REQUEST FOR INFORMATION FORM

RFI #	RFI#001
DATE	4/14/2020
DATE NEEDED BY	4/14/2020
PROJECT NAME	Oxnard Union HS - 618

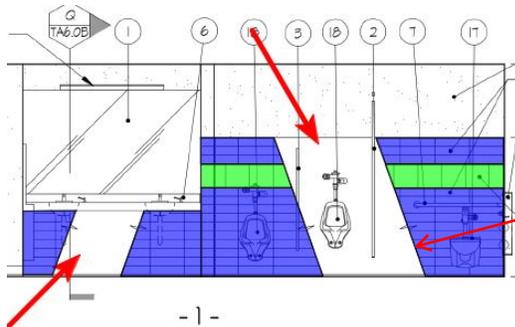
Can you please provide clarification or details on this section on drawing TA4.0 ENLARGED RESTROOM PARTITION PLAN & REFLECTED CLG. PLAN. I am not able to find a detail for this area. Please see red arrows.

these are called "cut lines". it is a standard architectural drawing method to not draw an entire pattern for ease of clarity and for less drawing. the tile patterns colored green and blue are continuous.
